From: Steven King
Sent: 24 April 2026 13:45:57 UTC+01:00
To: "'Prideauxplanning@gmail.com'" <Prideauxplanning@gmail.com>
Subject: Re: Development Site At Former Tower Car Sales, Tower Close, East Grinstead - DM/26/0432

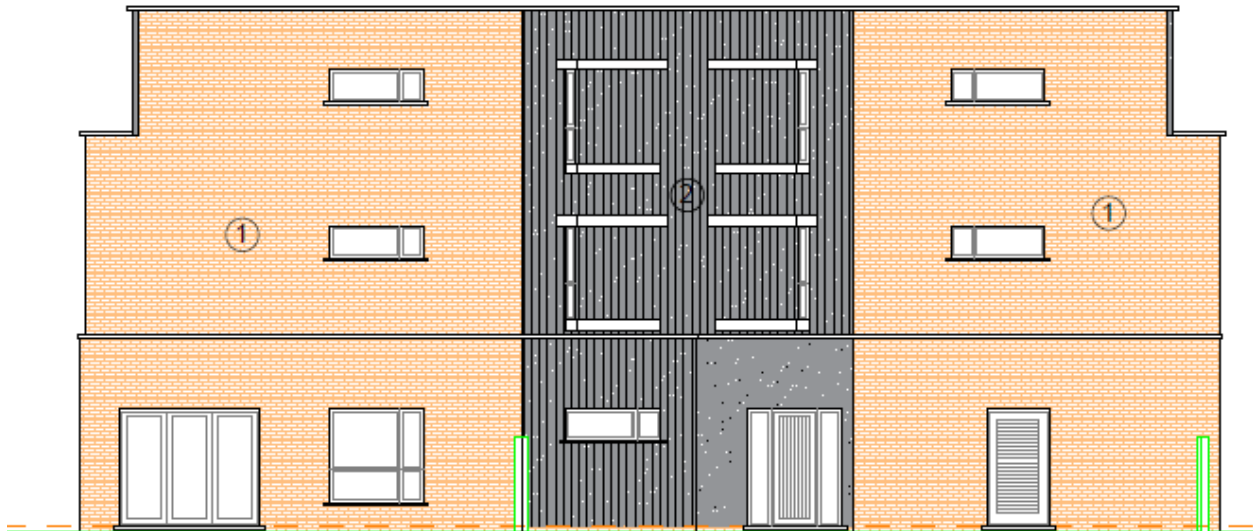
Further to my previous e mails re the above planning application, I have noticed a further discrepancy between the submitted plans and what has been constructed on site. The extract below is from plan number TOC-400 A, which is entitled Existing Floor Plan Showing Flat 1A.

However, what is show on the floor plan does not align with what is shown on the Existing South East Elevation on plan number TC.01 PL08 J3, as shown in the extract below.

The above elevations are incorrect as they do not show the correct arrangement of the windows and doors and do not align with what is shown on the floor plans.

I'd be grateful if this could be corrected please.
